March 22, 2024

**RE: Draft Supplemental Environmental Impact Statement for the Glen Canyon Dam Long-Term Experimental and Management Plan dated February 2024**

Figure 3-24  
Smallmouth Bass Capture Locations in the Grand Canyon prior to 2022 and 2022-2023

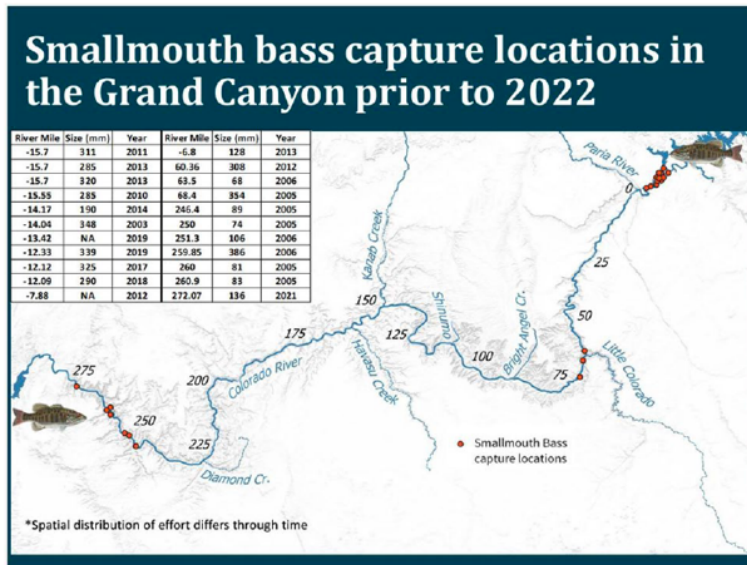
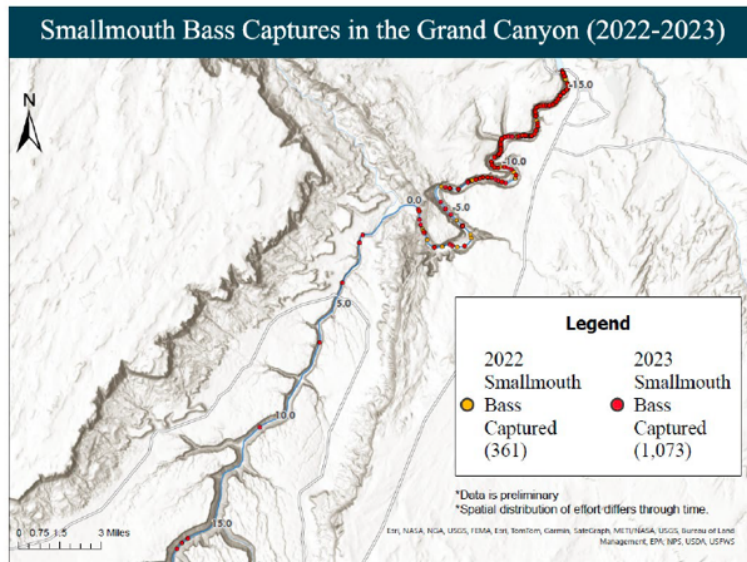
River below Glen Canyon Dam, but are still mostly heavily concentrated in Marble Canyon above Lees Ferry, as shown in Figure 3-24 from the Draft SEIS, reproduced below:

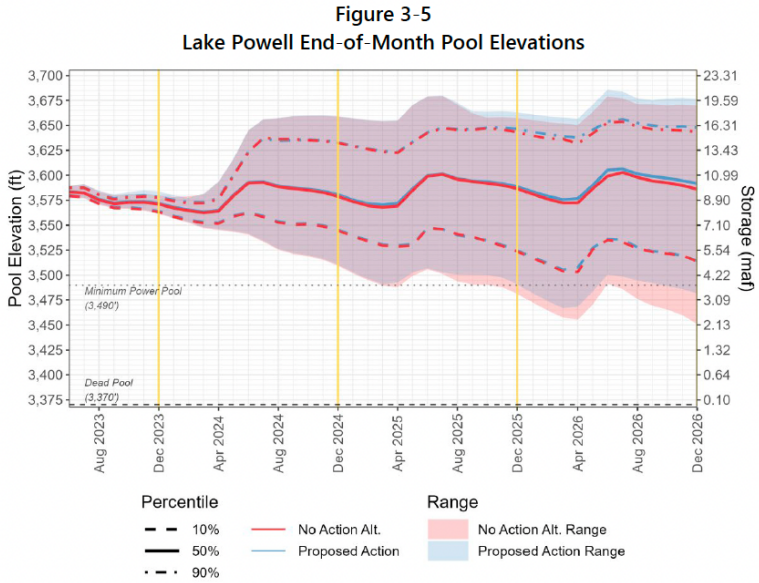
alternative.<sup>19</sup> It should be noted that these percentages may be a little misleading in that these are estimates for the entire year. As shown in Figure 3-35<sup>20</sup>, water temperatures of Glen Canyon Dam releases are not predicted to reach anywhere near the temperature threshold of 15.5°C for about half the year (December through April), and the median release temperatures do not reach this threshold until late summer August to November. Thus, it would be helpful for Reclamation to revisit this analysis to separate out the population growth by month, week, or day (e.g. the % of traces in July that showed population growth of lambda greater than 1), based on how many times the 15.5°C threshold is reached and for how long it continues. This would help assess the efficacy of the flow options and provide more granular picture of what operations under these alternatives might look like in a given summer. Since we do not have access to that analysis, we use the existing preliminary modeling as evidence to inform this analysis.
